NEI 17-01, Comments, Revision 6

**Industry Guideline
for Implementing
the Requirements of
10 CFR Part 54 for
Subsequent License
Renewal**

March 2017

Figure 4.2-1: Identification of AERMs

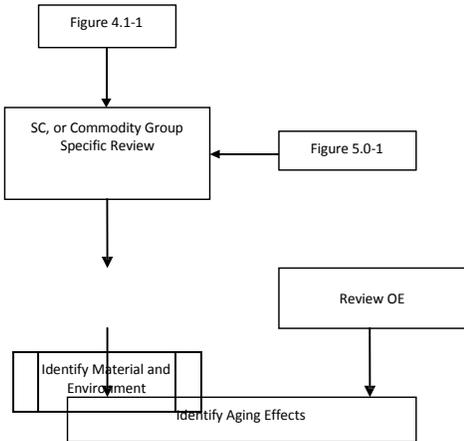
Commented [BB16]: For the steps in the middle of the flow-chart where an applicant identifies an exception to one or more program element criteria in a GALL-SLR AMP, the applicant would also have to provide a justification on why the applicant's modified GALL-SLR approach, as subsection to the identified exception or exceptions, is sufficient to demonstrate continued acceptance under the adequate aging management requirements in 10 CFR 54.21(a)(3).

Figure 4.3-1: AMP Review

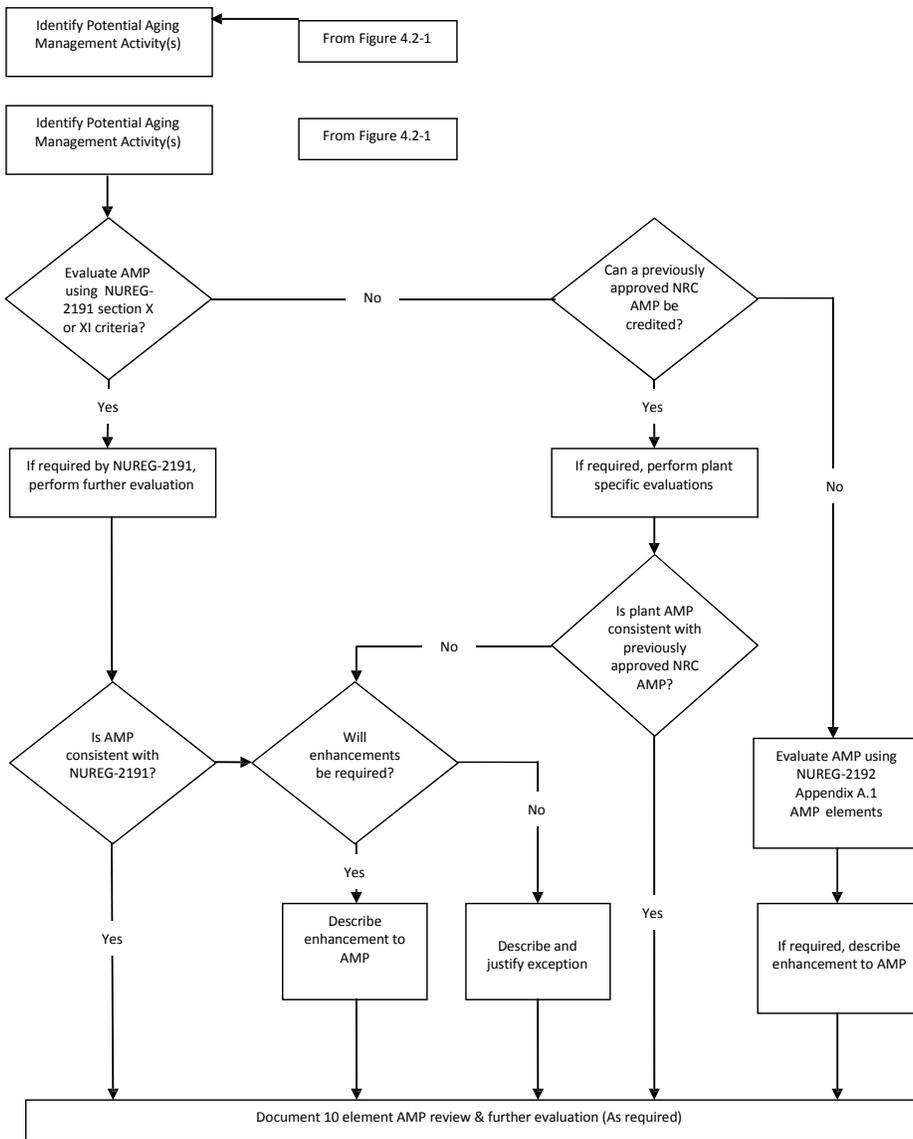
Commented [BB23]: The block "Is plant AMP consistent with previously approved NRC AMP." Is misleading. Many GALL Revision 1 and Revision 2 AMPs were revised by ISGs. The previous NRC approval may no longer be valid. Add a footnote to this block:
Previously approved AMPs might require changes based on subsequent GALL Report Revisions, Interim Staff Guidance documents, and changes incorporated in the GALL-SLR Report

Commented [HA24]: NEI might consider changing the words to "NRC AMP for SLR" to clarify that GALL Rev. 1 and Rev 2 do not apply? The standard for comparison is to GALL-SLR AMPs only.

Figure 5.0-1: Evaluation of TLAAs and Exemptions [§ 54.21(c)]

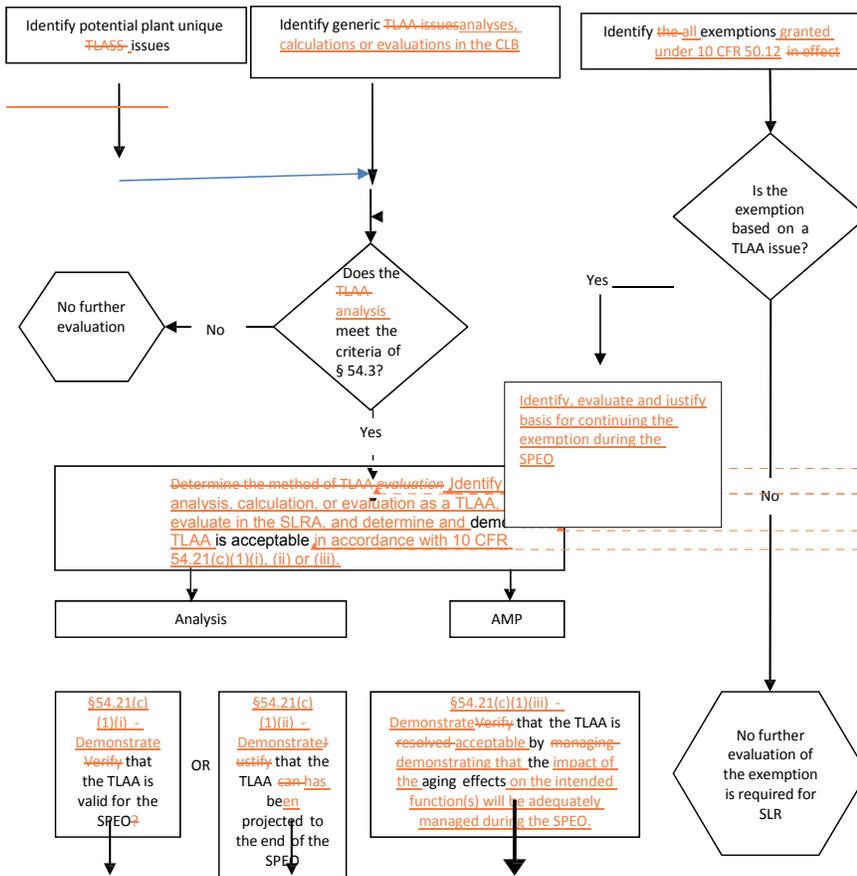
Commented [BB33]: The staff has a number of issues with the flow chart and recommends some changes to it.
